Master Processor PROM in PT5210 Varitime [™] Digital Sync Generator

Supplement to: PT 5210 Reference: Manual no. 9499 491 02211

Picture 1: The positioning of the master processor PROM. The lower right corner on the PROM is indicated by a cut in the chip. (Note, that code number on actual PROM may differ from Photo)

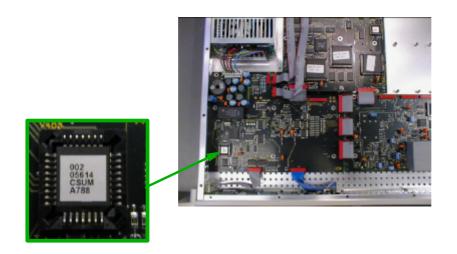
- 1. Open the PT 5210 by removing the top cover.
- Identify the master processor PROM on the processor module mounted flat behind the display module.See Picture 1
- 3. By use of suitable IC extractor remove the master processor PROM.
- 4. Insert the new processor PROM. Take care to orientate the PROM correctly.
- 5. Insert diode in fan circuit according to drawing.
- 6. Mount the top cover on the PT 5210.
- 7. Perform a factory reset: While pressing the two buttons ARROW RIGHT and ARROW LEFT simultaneously turn on the power.
- 8. Observe that the display reflects the changes included with the master processor change.
